# KEENE INFRASTRUCTURE IMPROVEMENTS **PHASE 2 PRELIMINARY DESIGN** **CENTRAL SQUARE**

MSFI COMMITTEE MEETING

MAY 08, 2024

# KEENE PHASE 2 | CENTRAL SQUARE DESIGN REVIEW WORKSHOP #3

## SINGLE LANE AT NORTH OF SQUARE

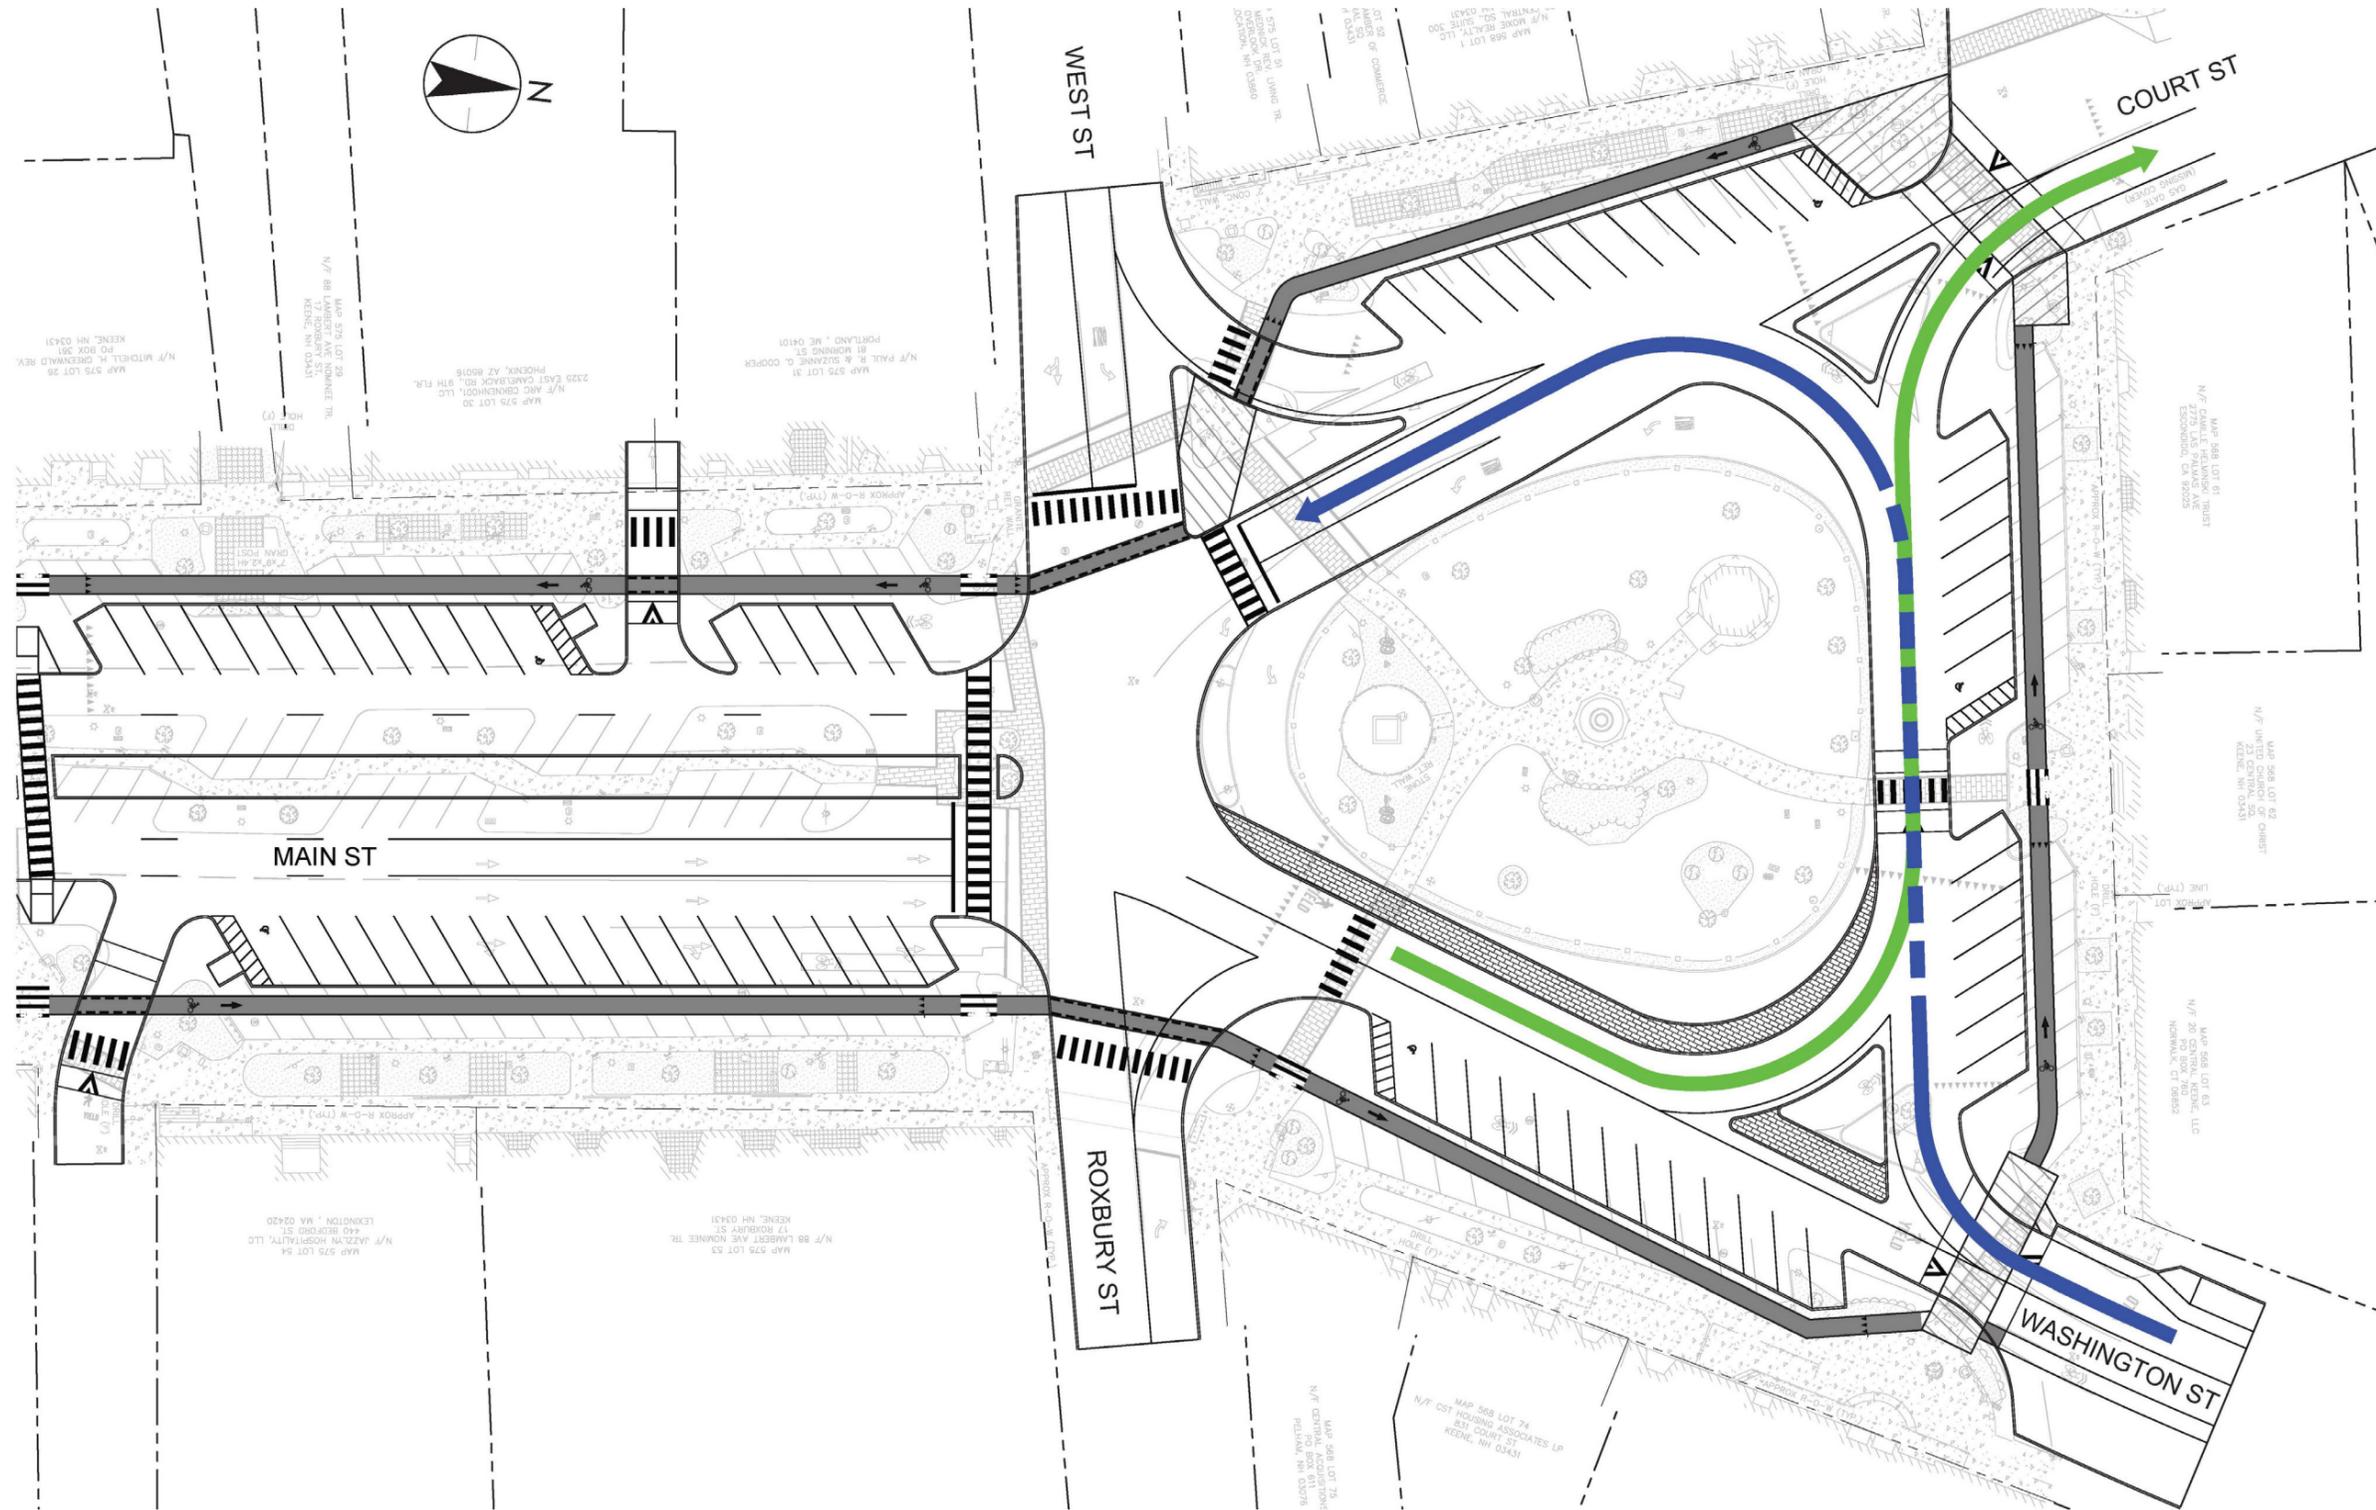
- The U-turn south of the intersection had the most support of the U-turn alternatives.
- The single/double lane across the top of the square was mixed, about 50/50 between the two alternatives.
- General concern that reducing from two southbound through lanes to one will create backups along Court and across the top of the Square.
- Strong support for the raised crosswalks and RRFB(Rectangular Rapid Flashing Beacon) as shown.
- Concern with reducing to a single left turn lane from crossover to Court/West Street.

## **Sidewalk/Streestcape**

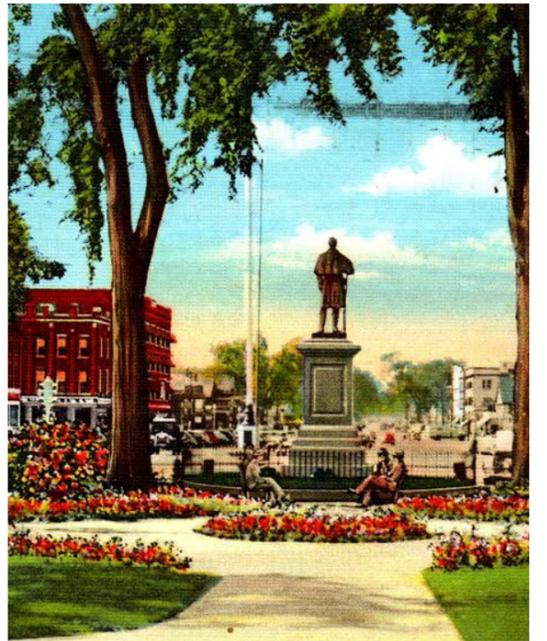
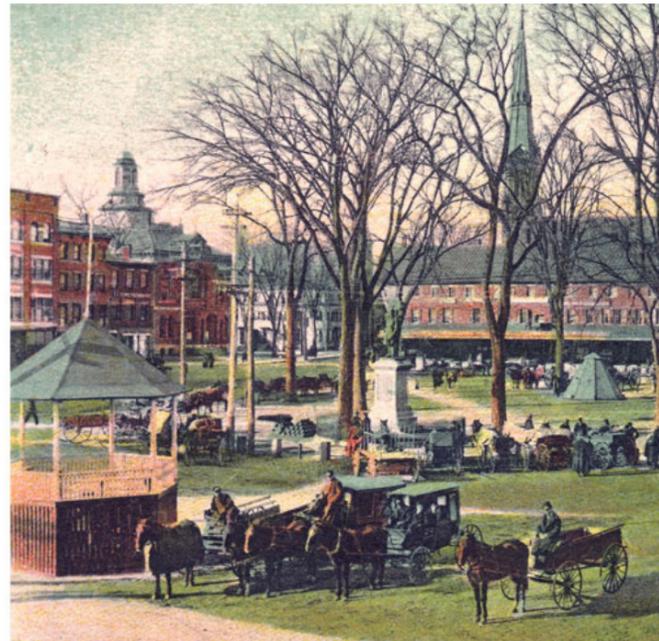
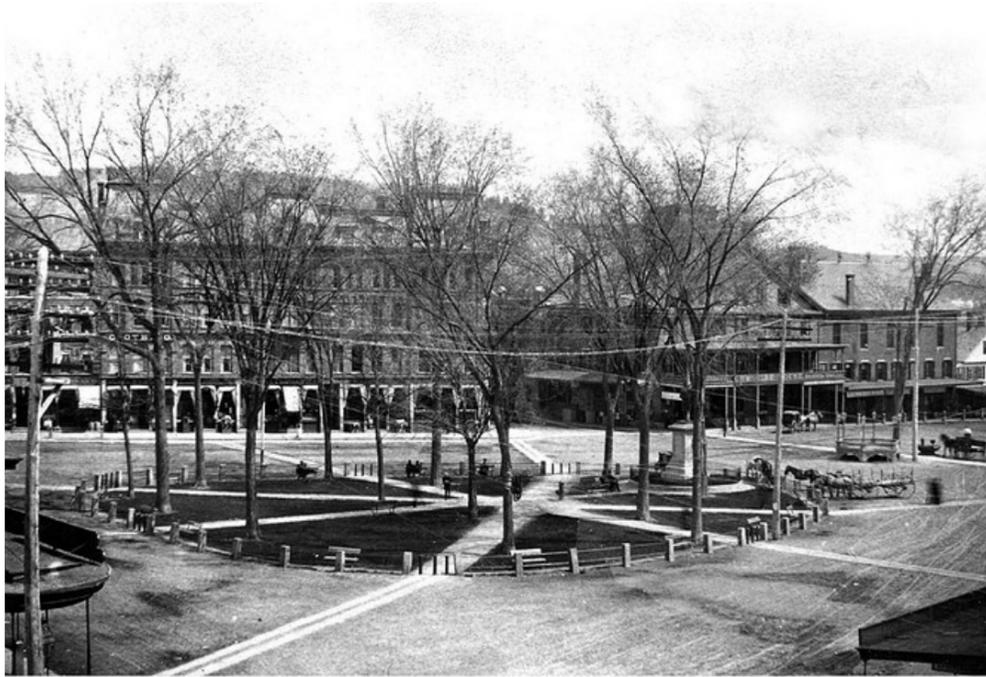
- Mixed reactions on RRFBs(Rapid Rectangular Flashing Beacon), trended towards against but some people were in favor of adding one at the midblock in front of the Church
- Positive feedback about raised crossings
  - Question on material/signage to indicate it's a space for both peds and bikes
- Some concerns over roadway narrowing, but positive feedback about improved streetscape width

- Discussion of intersection at Court and Winter
  - Should a stop sign be added on Court?
  - Should “do not block the box” striping be added to allow a left turn on Winter?
- **Businesses may be looking to be flexible with commerce zones**

## EXISTING ELEMENTS

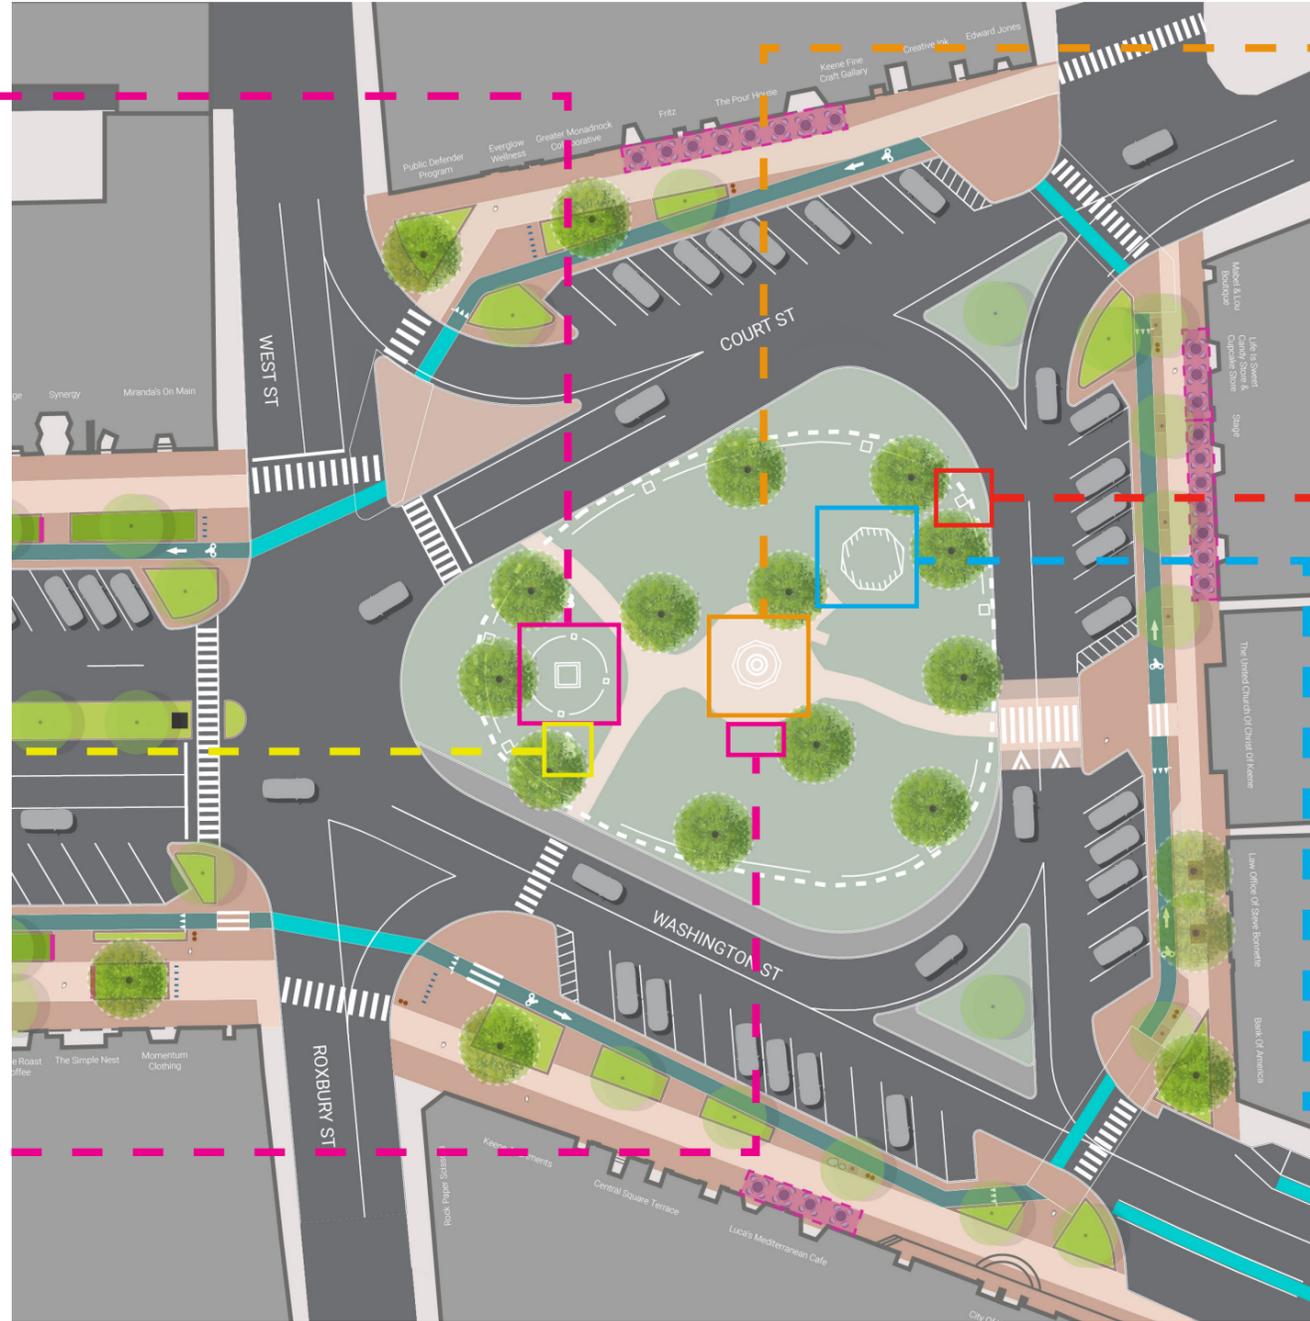
Soldiers' Monument - Should statue be moved out to the nose to be more prominent?

Cannon - Should cannon/cannonballs be moved out to the nose to be more prominent?

Bench - Should more bench seating be provided?

Bollard - Granite post and chain detail to be moved to perimeter?

Gazebo/Bandstand - Should Gazebo/bandstand be moved to provide more space around it? prominent?

## OPTION 2 - ENHANCED

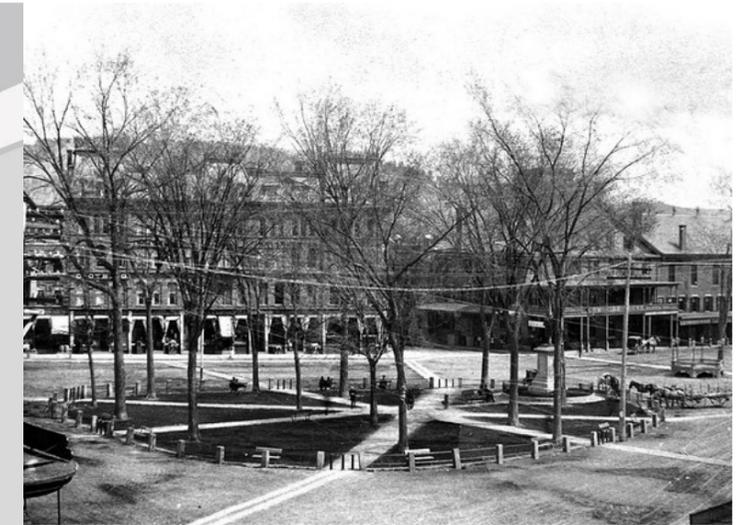
### - General preference for Option 1 Minimal and Option 3 New

- People liked the directness of the paths, especially the connection from Court St to Washington St crossing, beneficial for when there are performances and want to avoid the crowd near bandstand
- People generally wanted to maximize the green space, felt the perimeter path was not needed and busy
- Concern about removing the honeylocust tree for the new path in Option 3
- Current number of benches are fine, people like to come with their own chairs and blankets for performances
- General preference for brick or unit pavers as accents in key areas

- Many people thought the water feature should be upgraded and improved, has issues turning on and does not look great, it does not buffer traffic noise

- General agreement on expanding stairs at Gazebo, open to relocation to increase seating area during performances, likes the wood aesthetic but not tied to this specific structure

- Statue can stay in place or relocated south to make room for more green space, no strong opinion either way

- People generally agree that shorter crosswalks on Washington and Court was a positive and safer and easier to access the green, supportive of raised crosswalk at north end of the square

- Need to maintain traditional New England character

- Need to protect existing trees
